A D D E N D U M N O . 2

Project: EOU Ballfield Complex
RFP #: #FP-2022-09B
Date: April 7, 2026
Subject: Bid Form & Existing Conditions Plan Addenda

This three (3) page addenda changes the contract documents as follows:
modifies the bid due date to Tuesday April 16, 2026, the package 'A' bid form, and the overall civil grading plan to answer bidder questions.

C-110

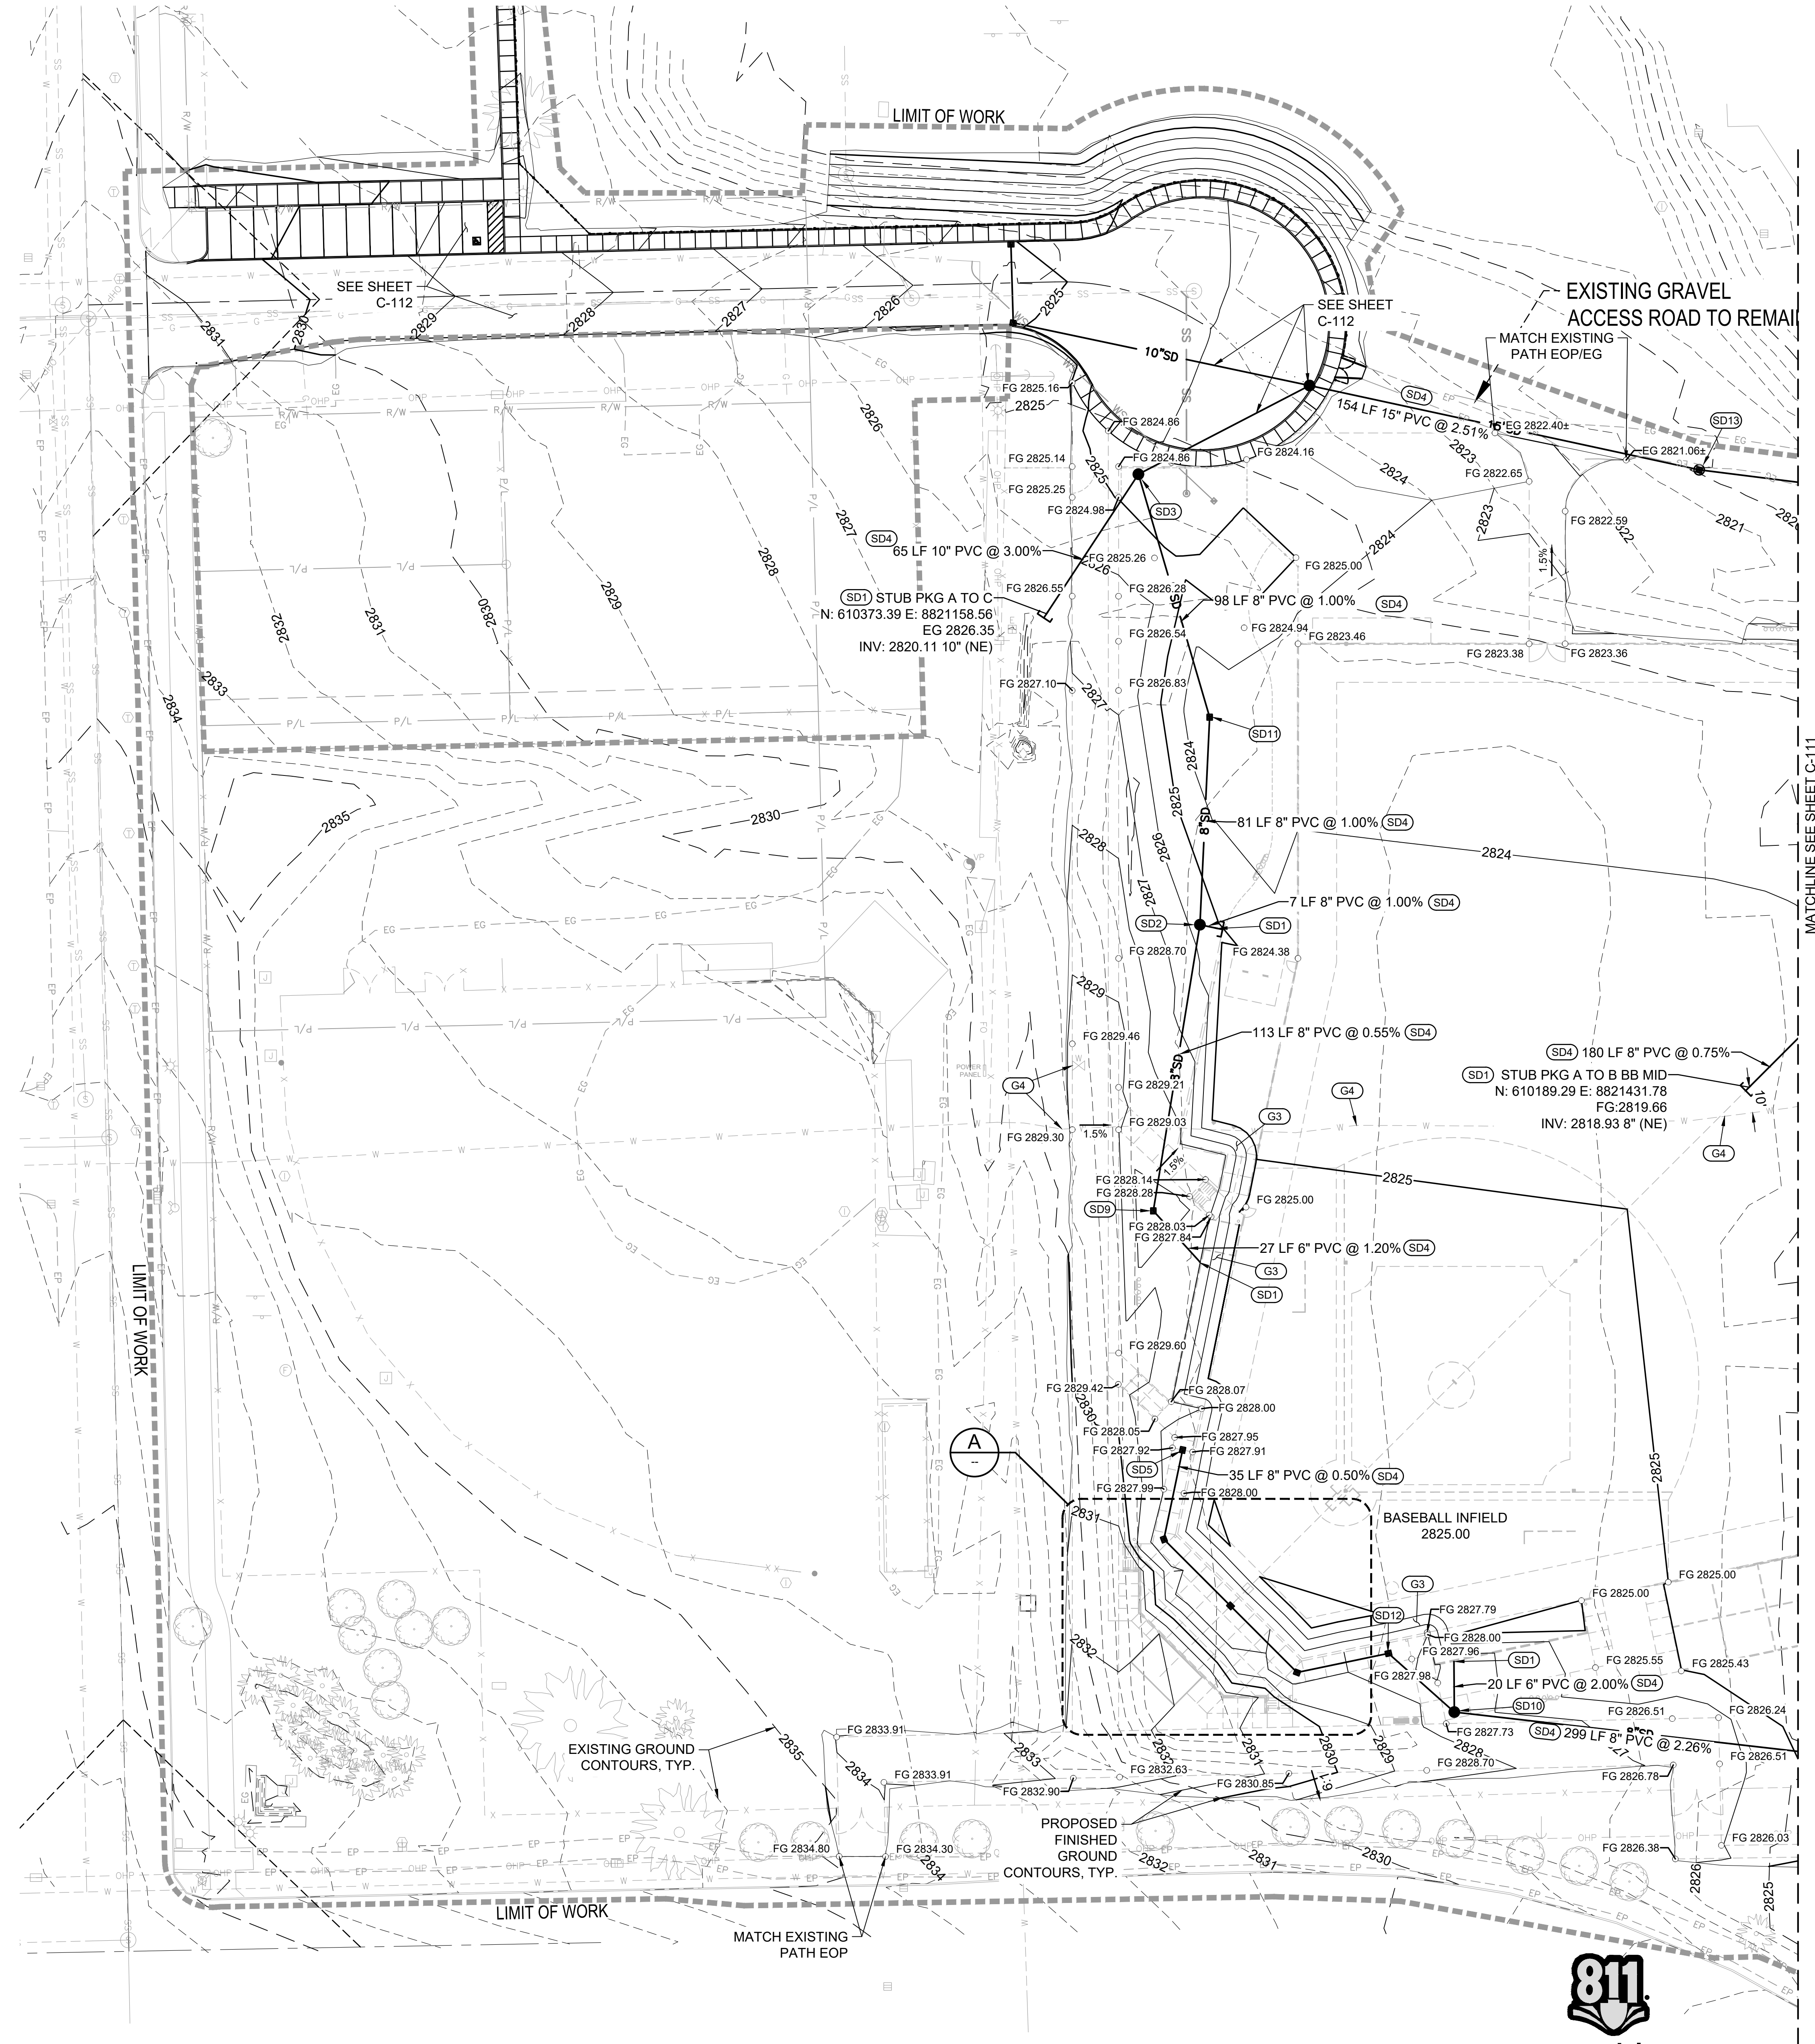
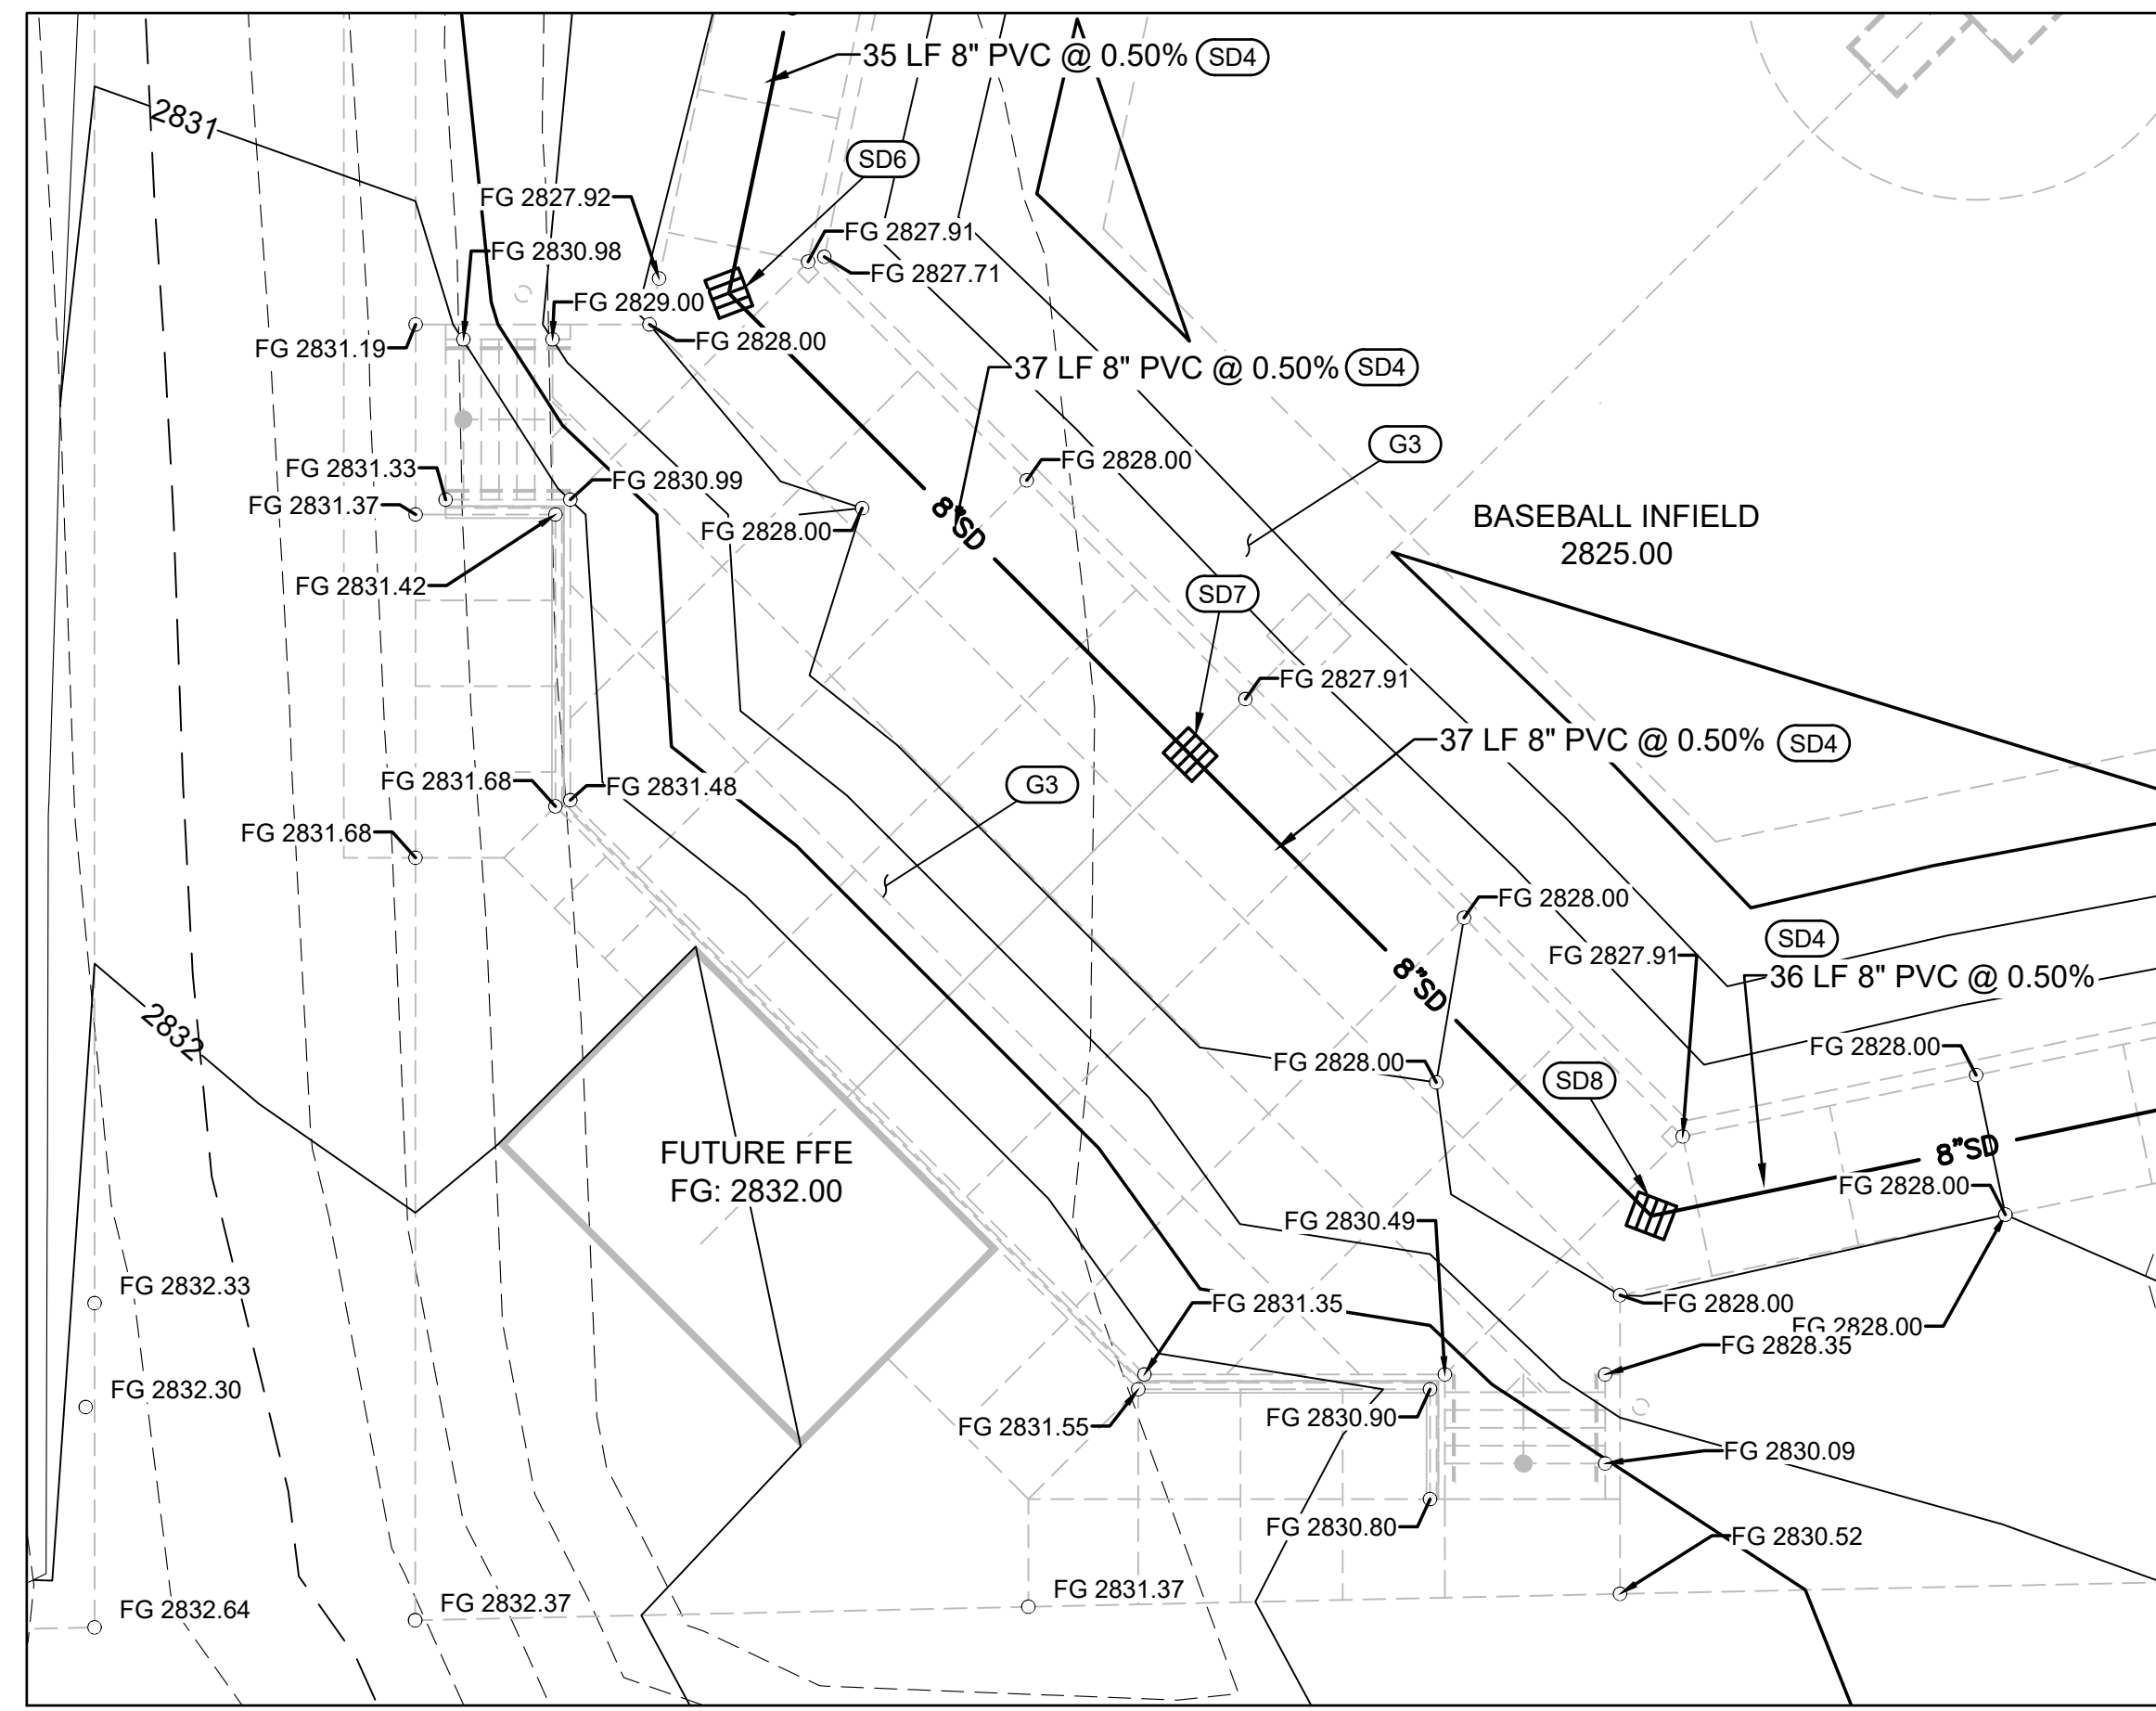
Package A SHEET C-110

The existing contours have been updated to match other sheets. See area north of E Ave where EG was extended to include data at the football parking lot.

sheet number
LC1.00

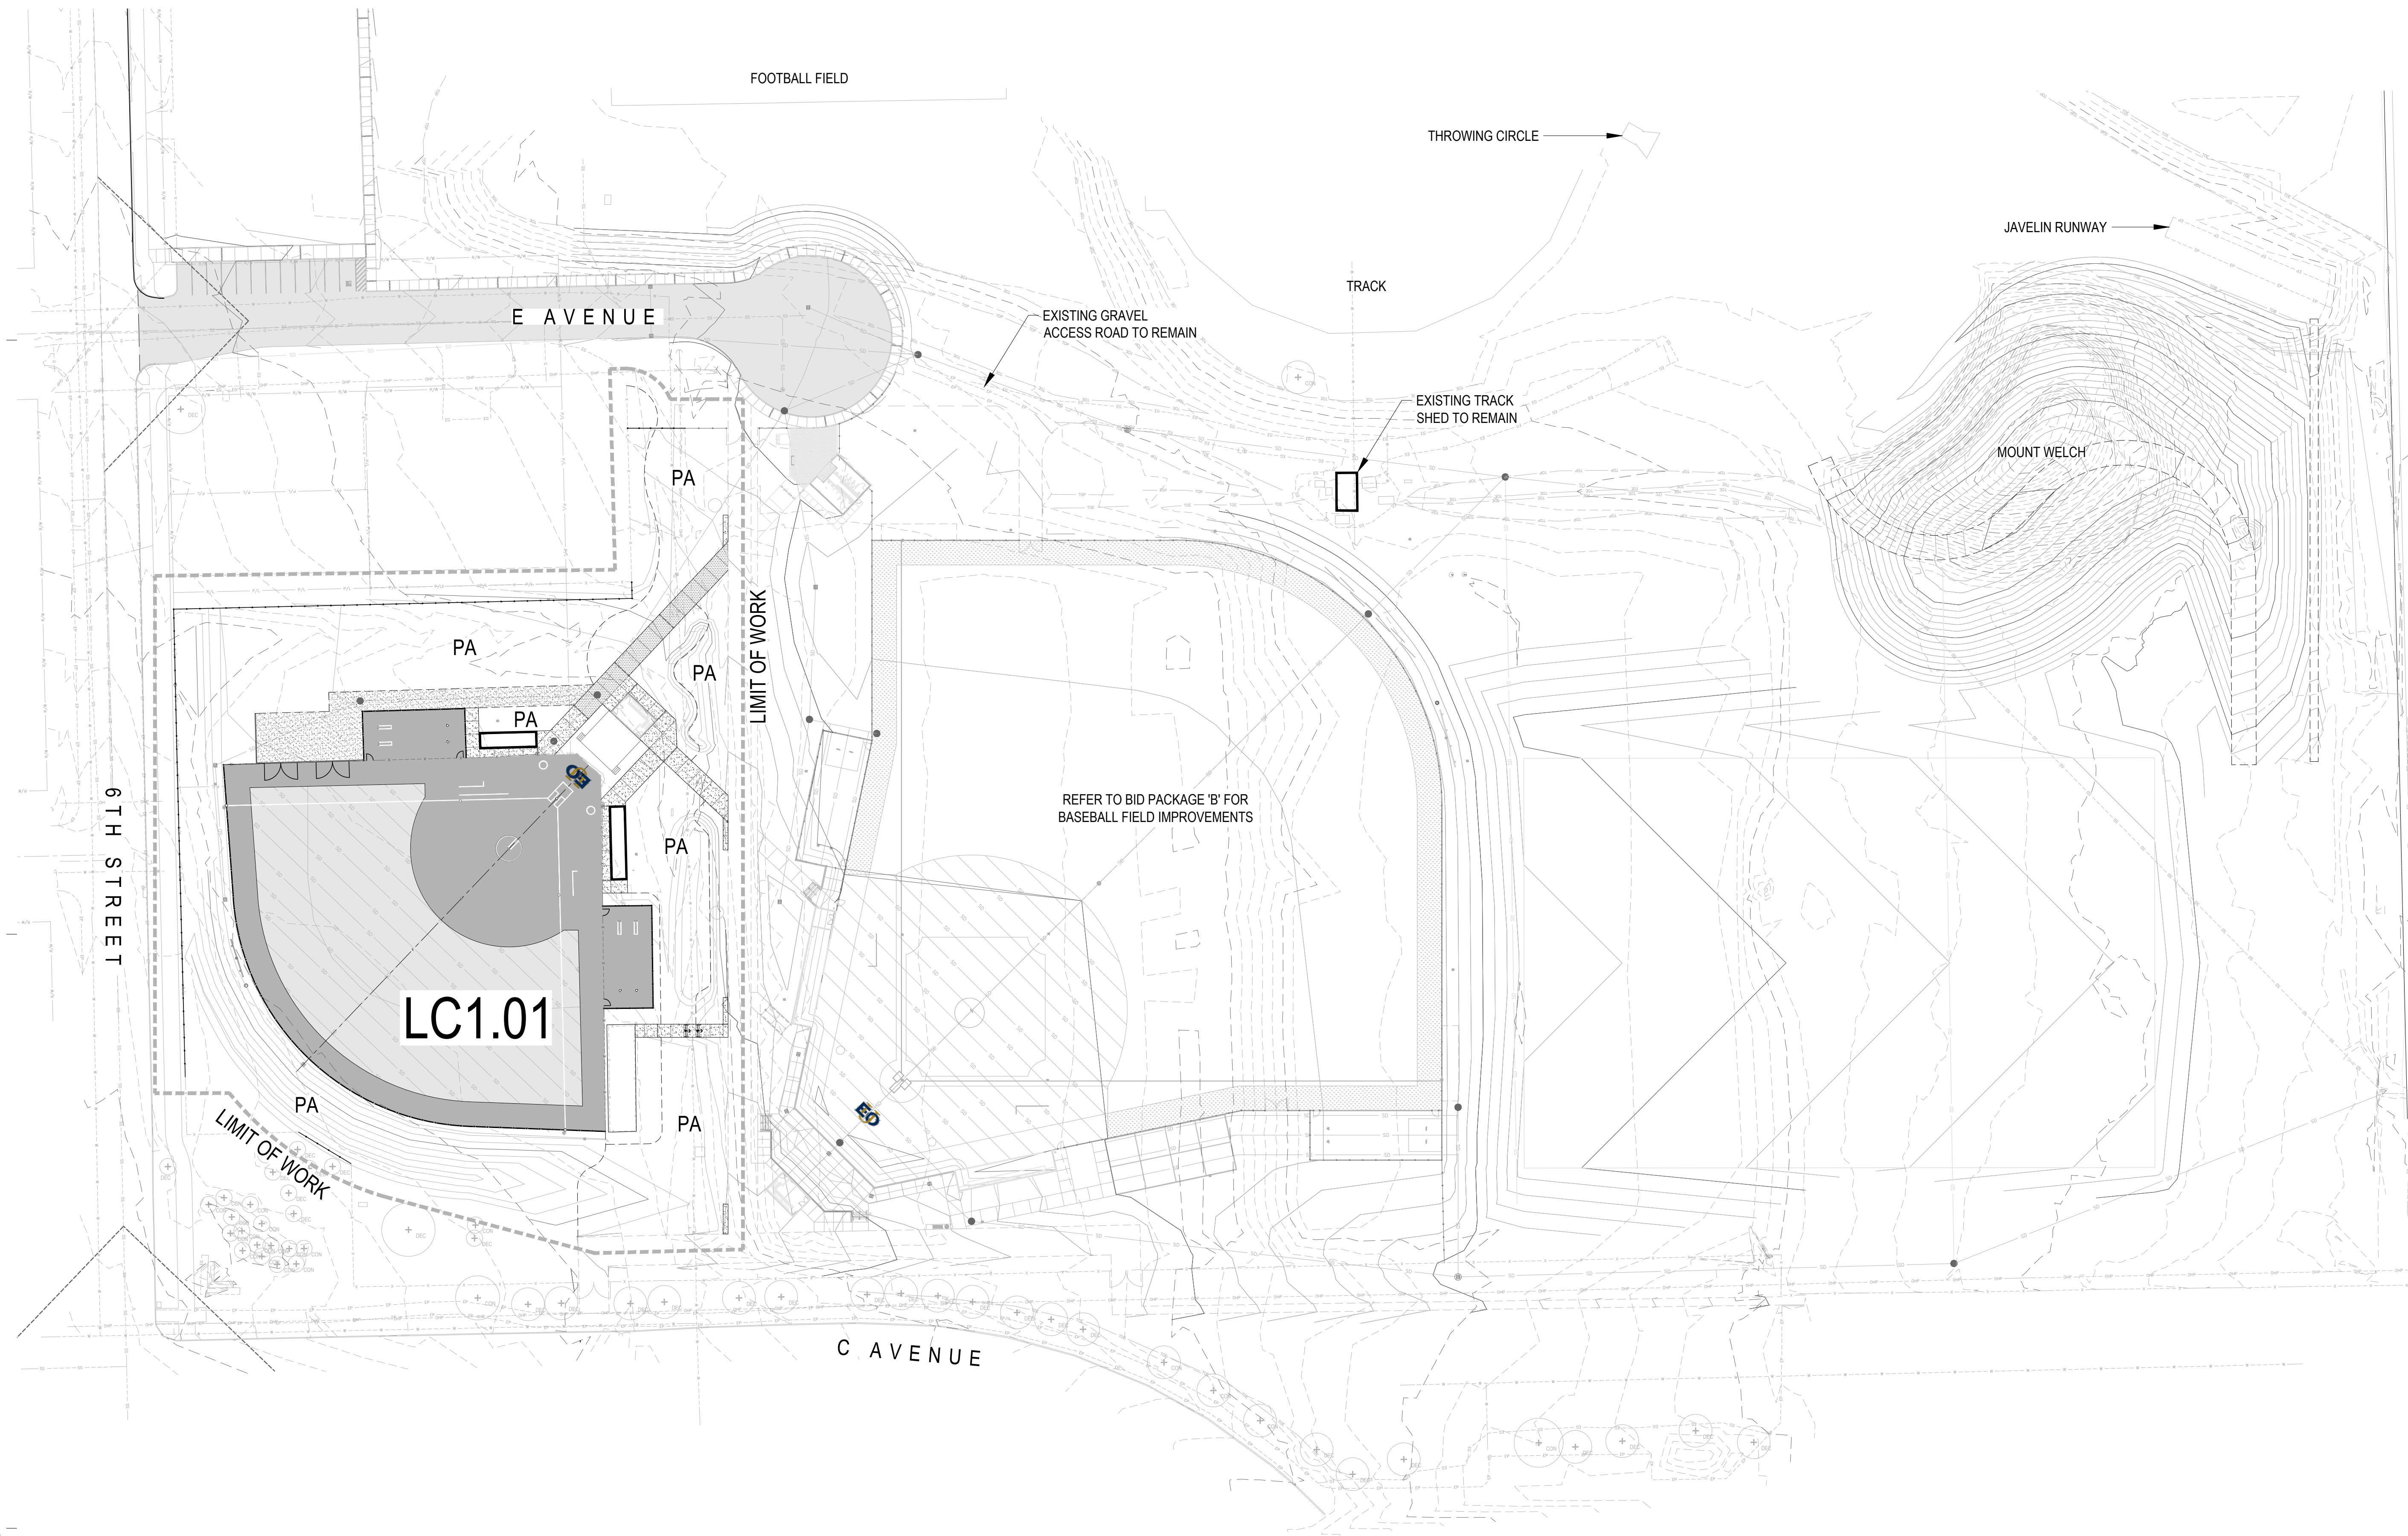
Package C SHEETS LC1.00, LC1.01, LC1.01.2, LC1.02

These sheets have been revised to indicate drawing scale and north arrow.
